November 21, 2016

Re: Final Environmental Impact Statement for Effects of Oil and Gas Activities in the Arctic Ocean—NOAA-NMFS-2016-25475

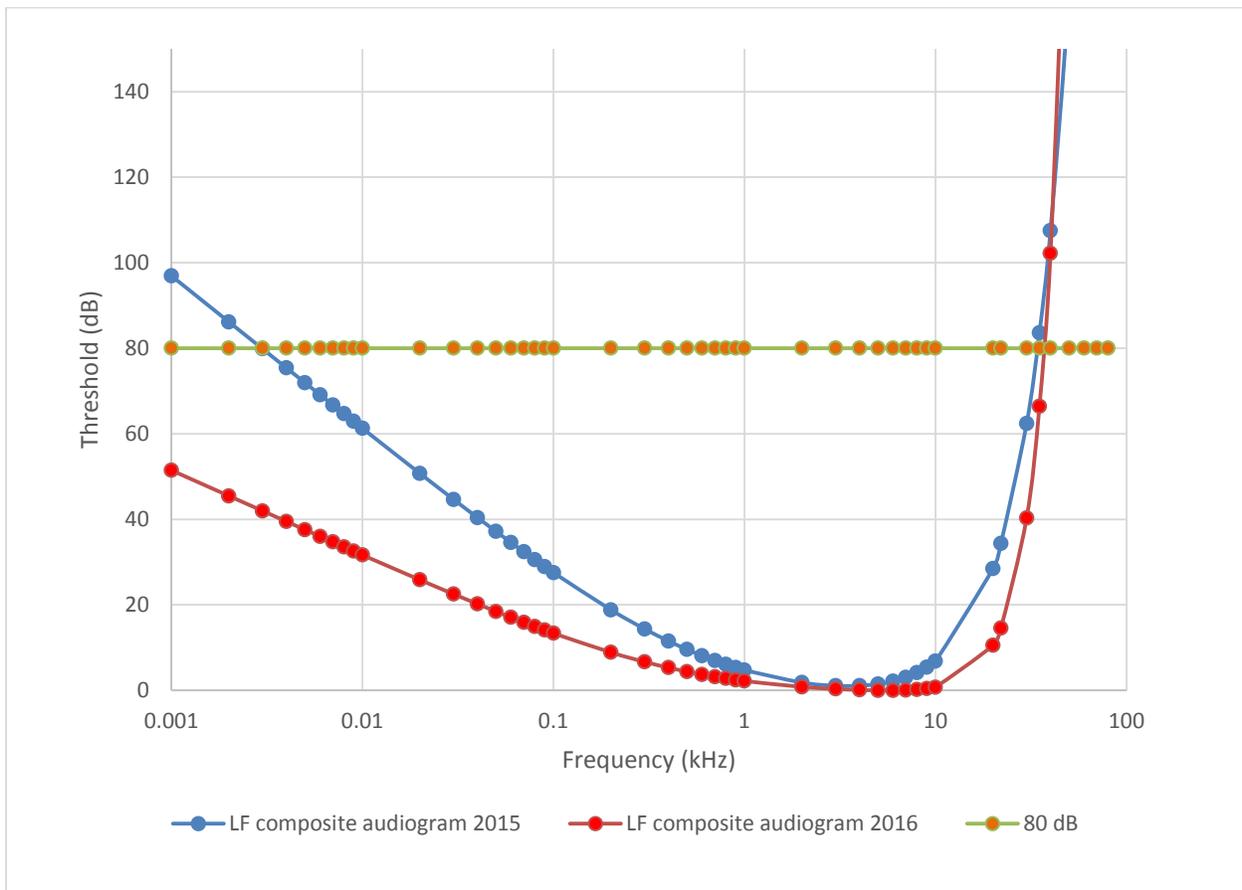
NOAA recognizes that “[m]ost mammals for which thresholds have been measured have low-frequency slopes ranging from 30-40 dB/decade.” Accordingly, the audiogram, and therefore the weighting function, should change from zero dB at 1 kHz to 30-40 dB at 100 Hz, and 60-80 dB at 10 Hz. However, instead of using the data that NOAA acknowledges are most accurate, NOAA proposes the “most conservative” metric by arbitrarily halving the data-supported metric to arrive at the proposed 20 dB/decade slope. The significance of this proposal, and its departure from the best available information, is readily depicted in Figure PC1,⁵ which clearly shows that the NOAA-proposed slope differs significantly from the two sources referenced by NOAA (Cranford and Krysl 2015; Houser et al. 2001). At 100 Hz, NOAA’s new proposal predicts hearing that is only 10 dB worse than best hearing, whereas both the Cranford and Houser models predict decrements of 25-35 dB at the same frequency. The slope of the proposed curve from 1000 to 10 Hz is less than 20 dB/decade, but the slope of the Cranford and Houser models is approximately 25 dB/decade. NOAA’s proposed departure from the best science is also highlighted in Figure PC2,⁶ in which the slope of the left side of the LF cetacean curve stands out as an anomaly compared to the other slopes presented in Figure PC2.

In addition, on page 7 of the 2016 proposed changes, NOAA reviews four models for frequencies of best hearing and states that these models predict “thresholds within ~40 dB of best sensitivity as low as ~30 Hz and up to 25 kHz.” However, rather than use the predictions of these models, NOAA proposes a curve that predicts LF cetaceans can hear 30 Hz at 10 dB above best hearing, not 40 dB. Under NOAA’s model, whales could even hear sound at 10 Hz with only a 25 dB decrement from best hearing—which the best available science for baleen whale hearing modeling (*e.g.*, Houser et al. 2001; Cranford and Krysl 2015) and general mammalian hearing data strongly suggests is impossible. *See infra* footnote 8.

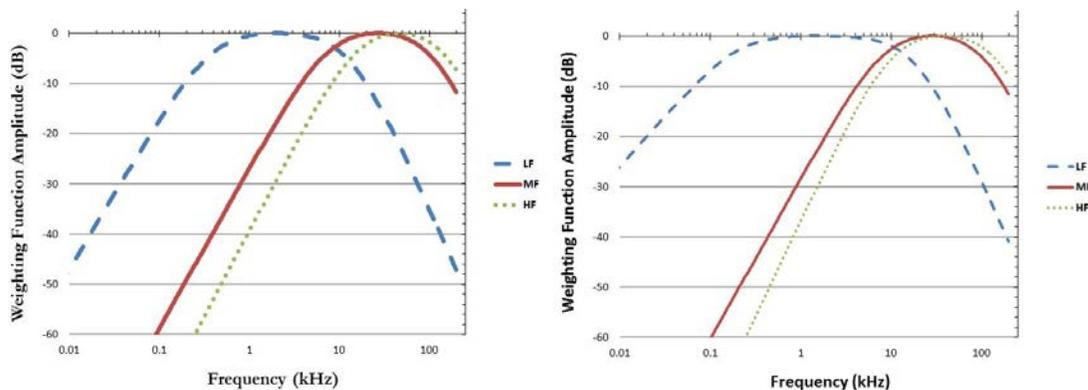
The impact of the new LF cetacean parameters is immediately obvious in our Figure 2 below, which compares Figure PC3⁷ of the new 2016 criteria (*see right plot below*) with the curve depicted in NOAA 2015 Draft Guidance (page 12) (*see left plot below*). In contrast to the similar shapes of all the 2015 weighting functions, the new LF cetacean curve produces a biologically unrealistic, extended, and flattened curve.

NOAA's proposed LF cetacean model also sharply deviates from data pertinent to other LF specialist mammals. For example, humans are LF hearing specialists that have a best hearing range of approximately 400 Hz to 16 kHz.⁸ But, unlike the LF cetacean model proposed by NOAA, human hearing ability is 25 dB below best hearing at 200 Hz—not the 10 Hz value generated by NOAA's proposed hearing curve. As another example, the kangaroo rat (another LF hearing specialist) has best hearing that starts to diminish at approximately 500 Hz. By 100 Hz, the kangaroo rat's hearing threshold is at least 10 dB above best hearing, and at 20-30 Hz is
